PROPOSAL FOR DRAFT AMENDMENTS TO REGULATION No. 55 (Mechanical couplings)

Note: The text reproduced below was prepared by the experts from ISO in order to propose the adoption of certain provisions given in ISO 3842:2006 and ISO 12357-2:2007 as a basis for a draft amendment to Regulation No. 55 (Uniform provisions concerning the approval of mechanical coupling components of combinations of vehicles).

Figure 16b — Mounting holes positions and tolerances on the tractor subframe and on the direct-mounted fifth wheel (For dimensions W1 and W2, see Table 12)

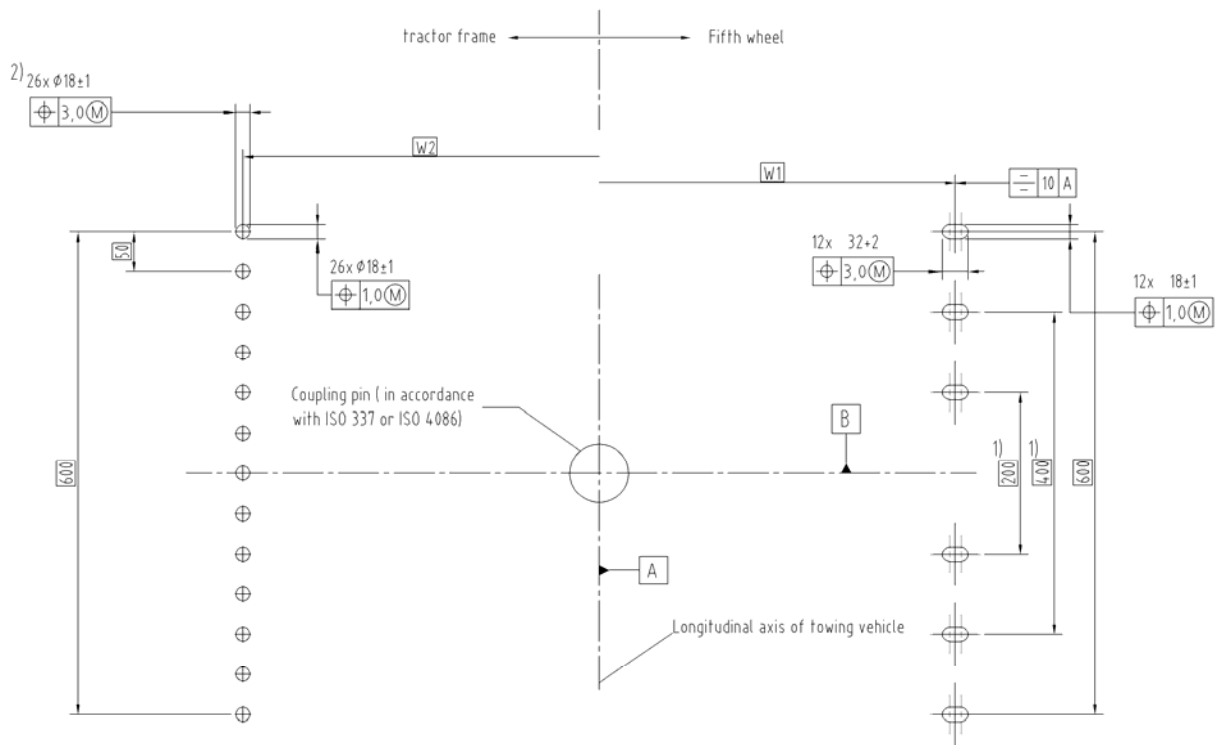
Paragraph 7.2, after figure 16a, insert a new figure 16b to read (including notes 1 and 2):

1 Alternative dimensions (spacing 100 mm or multiples thereof) may be used.

2 A minimum of 13 holes per side are required. A higher number of holes is recommended to give possibility to move the direct-mounted fifth wheel on the frame. The combination of elongated holes both on the fifth wheel and on the frame is not covered by this Standard.

Figure 17 — Minimum force introduction area"

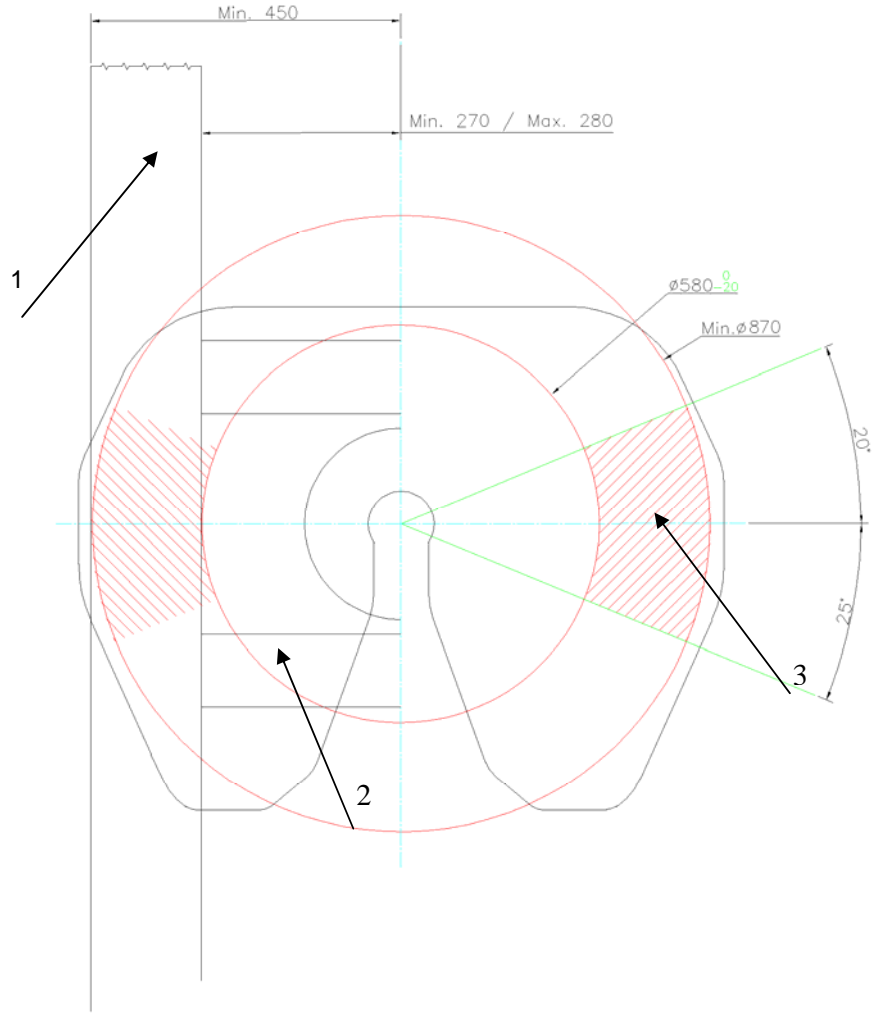
A minimum force introduction area at the top of the fifth wheel plate is defined as shown in Figure 17 in order to show the area in which the trailer plate forces shall be introduced (grease grooves on the surface of the fifth wheel top plate are allowed in this area)."

Annex 5, Paragraph 7, insert a new figure 17 to read:
